NUCLEAR ENERGY INSTITUTE

**SUBJECT:** Response to NRC Request for Additional Information on Proposed Interim Staff Guidance (ISG)-11: Environmental Assisted Fatigue for Carbon/Low-Alloy Steel

**PROJECT NUMBER:** 690

**Response to NRC Request for Additional Information  
on ISG-11, "Environmental Assisted Fatigue for Carbon/Low-Alloy Steel"**

Figure 1. LAS Uncorrected Data Plotted Against NUREG/CR-6335 Equations and 10% Endurance Limit Standard Variation for Various Quantiles

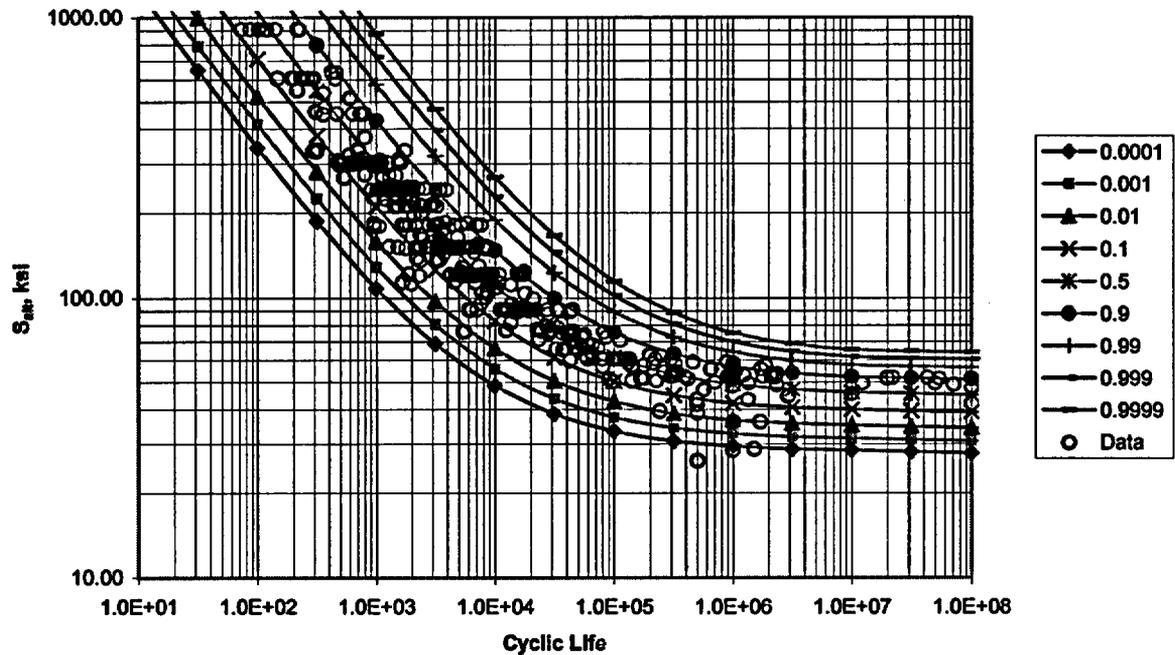
- A. *The revised probabilistic fatigue curves do not appear consistent with the data for carbon and low alloy steels. For example, compare probabilistic curves developed using the EPRI assumption for the standard deviation of the endurance limit with the data presented in Figure 14 of Attachment 1 of the submittal.*

Figure 1 shows the comparison of the ASME low-alloy steel air data from Figure 14 of Attachment 1 of the submittal with Equation 18 of NUREG/CR-6335 and the standard deviation of the endurance limit (10 percent of the endurance threshold) used in MRP-74. Indeed, there are a few points near the endurance limit that are low relative to the EPRI predictions. However, the bulk of the data are above the mean line.

Further study of the data plotted in Figure 1 revealed that the data falling below the curve represented A508 Class 3/Class 4 material with the fatigue testing conducted at an R-ratio ( $S_{min}/S_{max}$ ) greater than zero, versus the standard test approach using  $R = -1$ . Since the testing was conducted with a mean stress effect, the apparent stress is higher. Table 1 shows the eight lowest data points as an example.

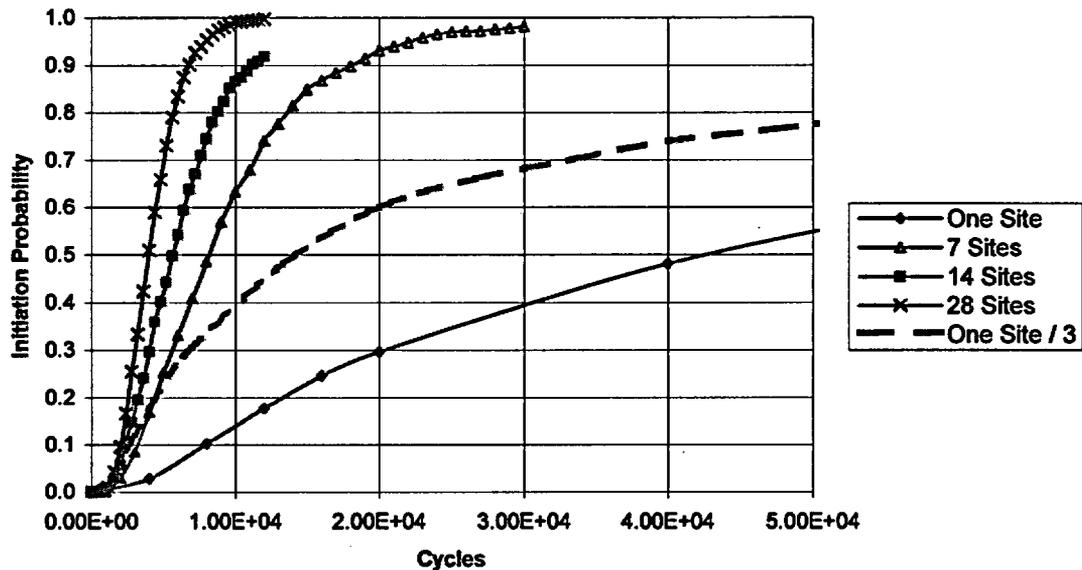
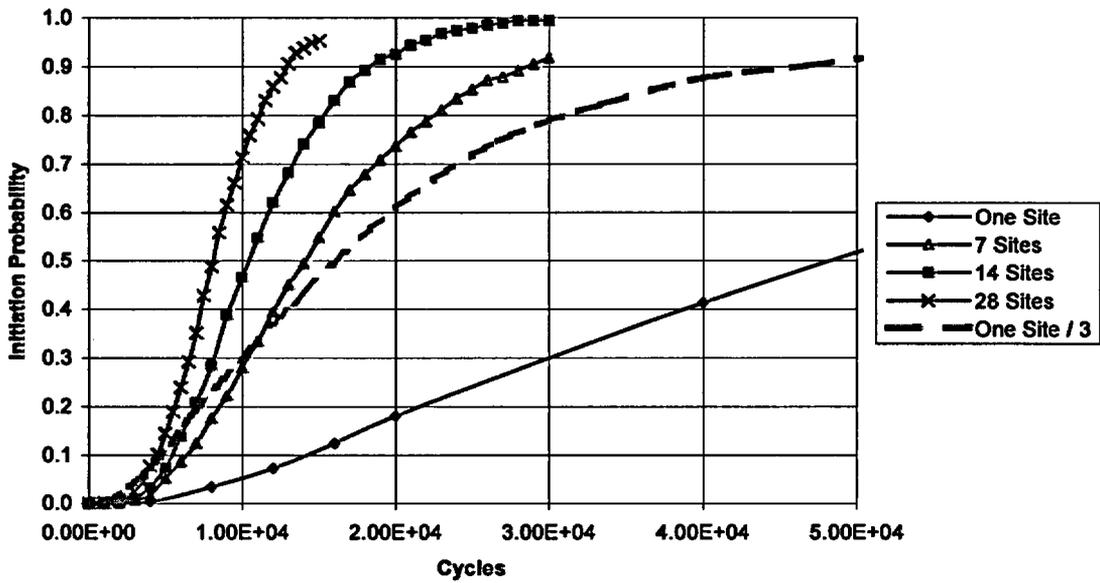
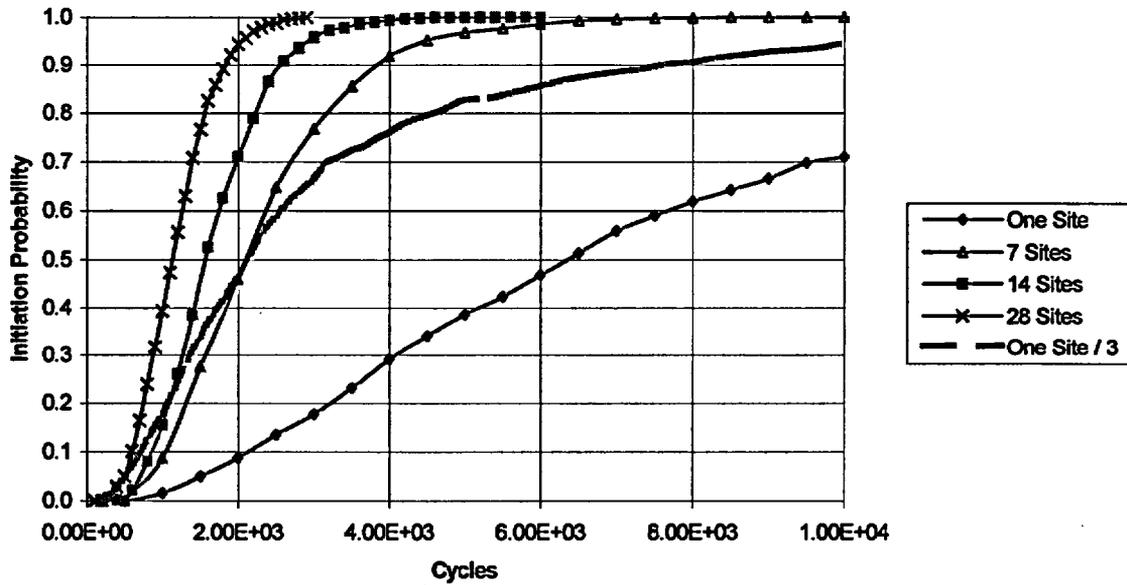
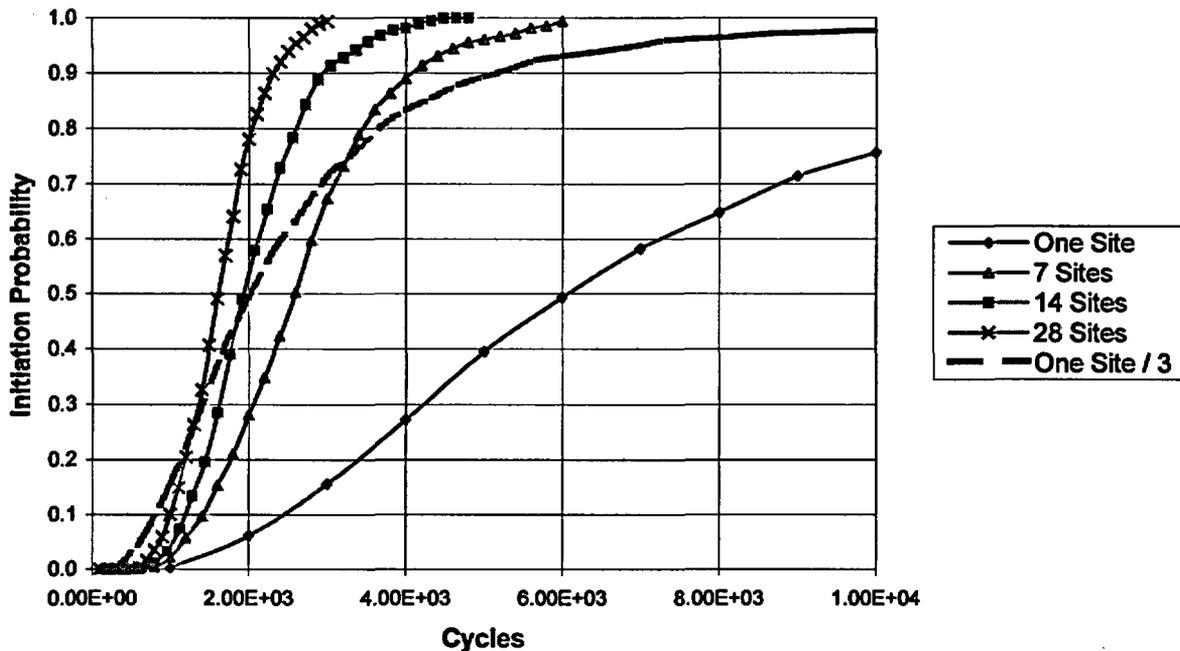
2. *The EPRI report, page 3-3, indicates that the ANL adjustment of ln(4), used to account for the differences between laboratory specimens and actual components, was included in the study in accordance with the discussion in the PNNL study. Section 4.7 of the PNNL study indicates that the ln(4) value was adjusted to account for the potential for multiple crack initiation sites. The PNNL study further indicates that the adjustment was calibrated against the data from the 9-inch diameter vessel tests described in the ANL report. Describe how this adjustment was applied in the EPRI study.*

To gain further understanding of this, evaluations were conducted representative of the carbon steel data points in Figure 26 of NUREG/CR-6335. For stress amplitude levels of 45 and 70 ksi, pcPRAISE analyses were run to simulate simultaneous fatigue initiation at 1, 7, 14 and 28 locations. The 14-location run was consistent with the "9-inch" vessel quoted in NUREG/CR-6674. Analysis was conducted for ambient temperature water conditions using the PNNL model used in NUREG/CR-6674 and the model described in Attachment A. In both cases, the model included the factor on the natural logarithm of 4 in the fatigue equations that introduced the factor of 4 for size/geometry and surface finish. Results of this analysis are shown in Figures 11 and 12 for the 45 ksi case and in Figures 13 and 14 for the 70 ksi case.

The results show that the probability of crack initiation increases with the number of loading cycles and with the number of locations around the circumference. The dashed line represents the single location probability with cycles reduced by a factor of three, as was determined to represent a conservative life adjustment factor as described in NUREG/CR-6674.

The first two cases (Figures 11 and 12) represent the lower-strain case in NUREG/CR-6335 Figure 26 for carbon steel. The cycles to the 50 percent probability of crack initiation is about 45,000 for both the PNNL and the Attachment A methodology, consistent with the mean of the two lower data points for the vessel testing. This indicates that the natural logarithm of 4 is an appropriate measure of reduction for size/geometry and surface finish effects for analysis of a single location. For the models with more locations being evaluated simultaneously, the number of cycles to initiation is

under predicted significantly, demonstrating the “double count.” Both figures show that the multi-locations modeling under predicts the probability of initiation except when there is a very low probability of initiation. The 14-location model predicts initiation significantly sooner than the single-model results corrected by the factor of 3 (the dashed line). Since initiation must occur prior to crack growth, the reduction by a factor of three is conservative, especially for components with diameter greater than 9 inches (which represent all of the components in Attachment A).

Results of the second case for higher stress amplitude (Figures 13 and 14) is consistent with the first case and adequately predict the higher stress testing at the 50 percent probability level. Although the method described in Attachment A predicts a slightly higher number of cycles to reach the 50 percent probability level, the reduction factor of three is still conservative. This is especially true since the carbon and low-alloy steel components of the evaluation are all significantly greater than 9-inches diameter.

Thus, the application of the factor of three for life-adjustment in the pcPRAISE analysis is appropriate.

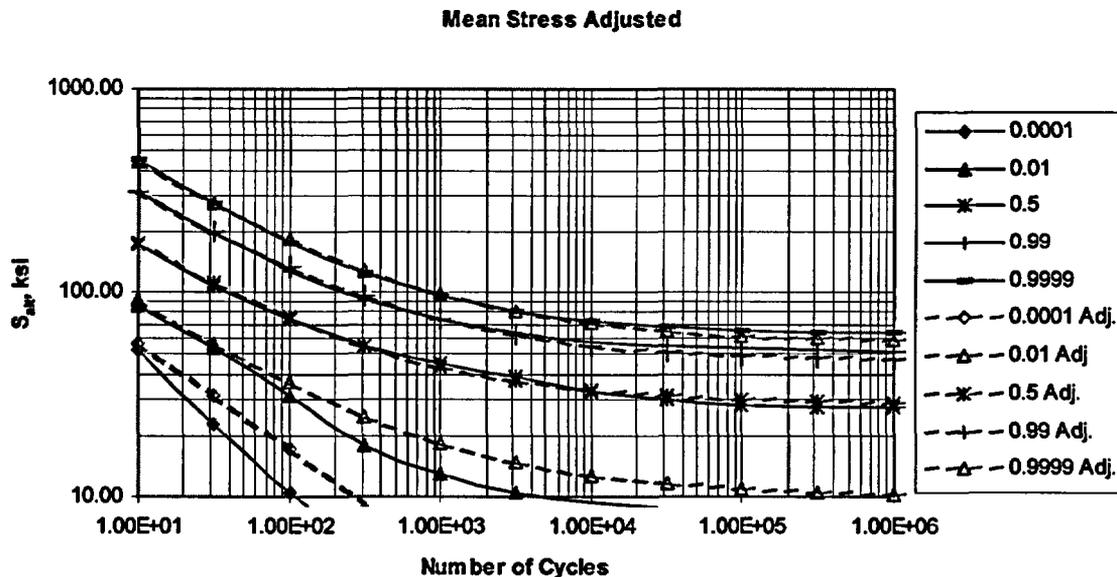
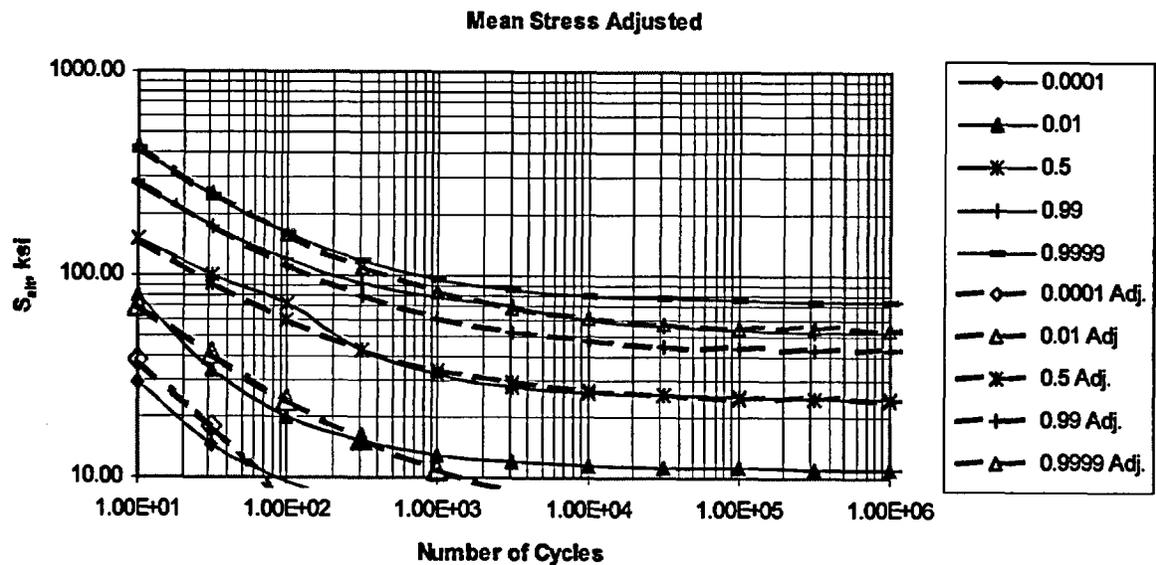
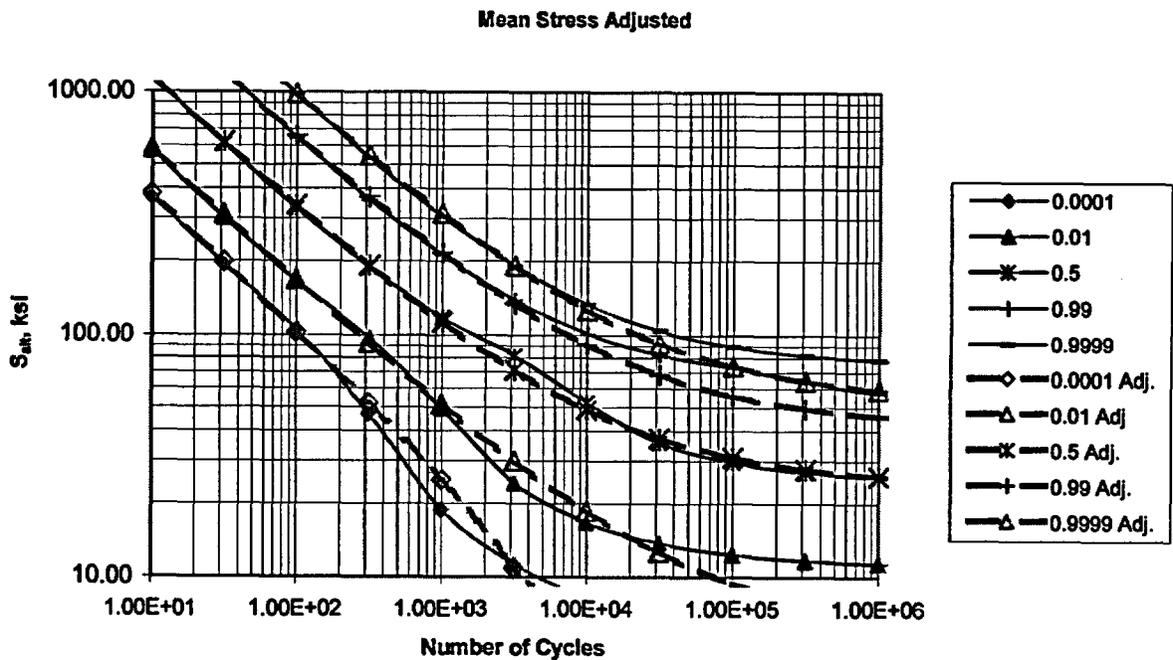
3. *The EPRI report, page 3-11, provides a procedure to account for mean stress effects. Show how this procedure was implemented in the evaluations presented in Chapter 4 of the report. Discuss the consistency of the mean stress adjustment used in the Chapter 4 evaluations with the mean stress adjustment discussed in NUREG/CR-6717.*

Thus, for an applied alternating stress, a corrected stress is used when determining the number of allowable cycles from the fatigue curve. Figures 15 and 16 show the difference between using NUREG/CR-6335 Equation 18 for carbon and low-alloy steels, and for using the NUREG/CR-6335 Equation 5 mean data curves, including the NUREG/CR-6335 coefficients for material variability, with mean stress corrections for  $S_y = 40$  ksi and  $S_{ult} = 80$  ksi for carbon steel and  $S_y = 70$  ksi and  $S_{ult} = 100$  ksi for low alloy steel, as were used in deriving the ASME Code curves and Equation 19. There are slight differences since the NUREG/CR-6335 modified fits to include data scatter are not exact fits of the modified Goodman procedure. However, the two are nearly identical, except that the mean stress approach used in MRP-74 is more conservative. Figure 17 shows a similar comparison for low-alloy steel with no environmental effects included.
